**NORTHEAST UTILITIES**

November 4, 1982  
Docket No. 50-336  
A02724

Millstone Nuclear Power Station, Unit No. 2  
Additional Information, Measurement Uncertainties

FIGURE 1

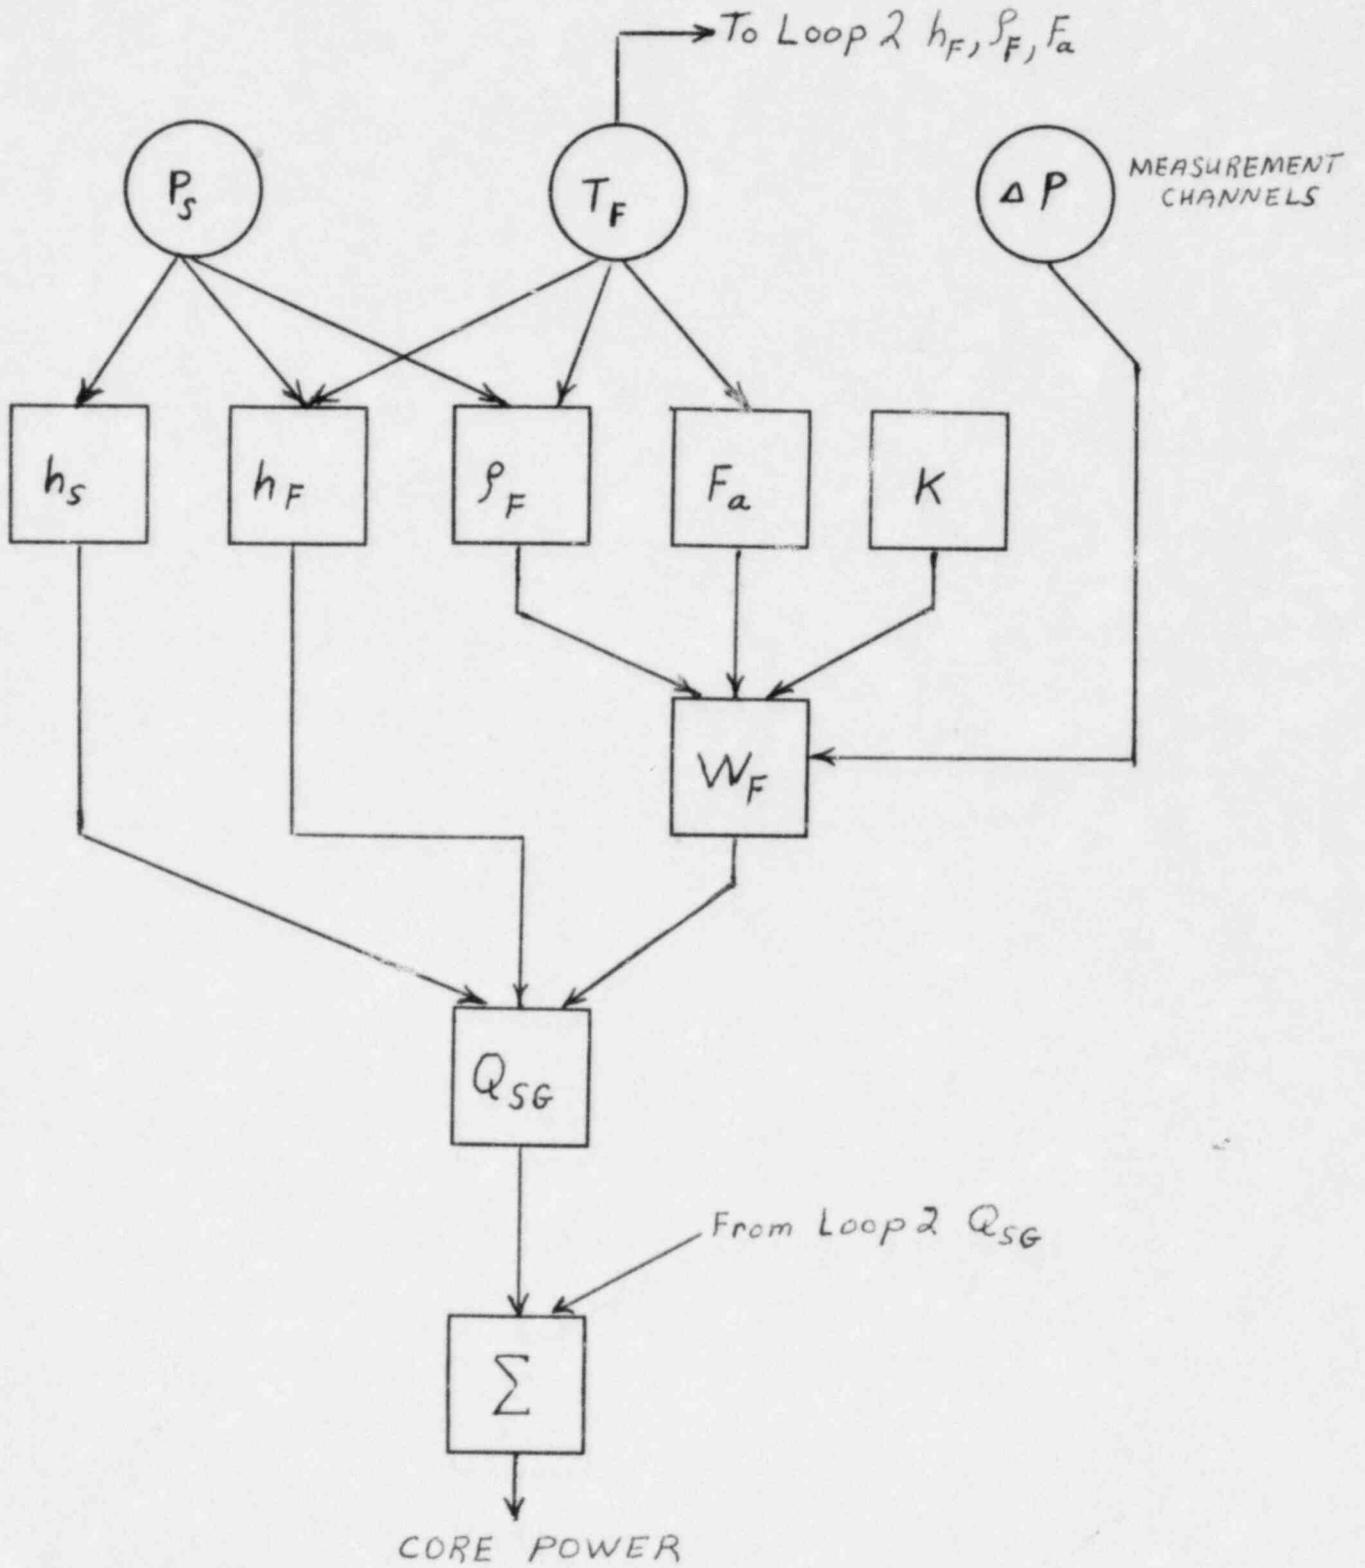
In some cases in your response, uncertainties which are not independent have been combined through the RMS technique. The RMS technique requires that the uncertainty contributions be independent. If they are dependent, their combined effect should be assessed through deterministic methods.

Three cases so identified are the feedwater venturi area expansion factor, feedwater density and feedwater enthalpy. These three factors are each dependent upon the feedwater temperature and are used in determining the core thermal power. Similarly, the feedwater density and steam enthalpy are both dependent upon steam generator pressure and are used in determining the core thermal power.

Correctly combine these dependent uncertainties deterministically to find if the uncertainty in the core power falls within the value used in the safety analyses.

Figure 1 provides a diagram of the measurements and calculations required to determine calorimetric core power. From Figure 1, it is seen that within each steam generator loop the steam enthalpy,  $h_s$ , feedwater enthalpy,  $h_f$ , and feedwater density,  $\rho_f$ , are dependent on the same measurement of steam generator pressure,  $P_s$ . Similarly, within each steam generator loop, feedwater enthalpy,  $h_f$ , feedwater density,  $\rho_f$ , and feedwater venturi area expansion factor,  $F_a$ , are dependent on the same measurement of feedwater temperature,  $T_f$ . The feedwater temperature measurement,  $T_f$ , also provides input to the Loop 2  $h_f$ ,  $\rho_f$ , and  $F_a$  calculations; therefore, the  $T_f$  error contributions are not only dependent within a single steam generator loop but also between each steam generator loop. The error contributions that are independent within each steam generator loop are the errors associated with the venturi calibration coefficient,  $K$ , the venturi  $\Delta P$  measurement, and the component of the venturi area expansion factor,  $F_a$ , associated with the uncertainty in the linear thermal expansion coefficient.
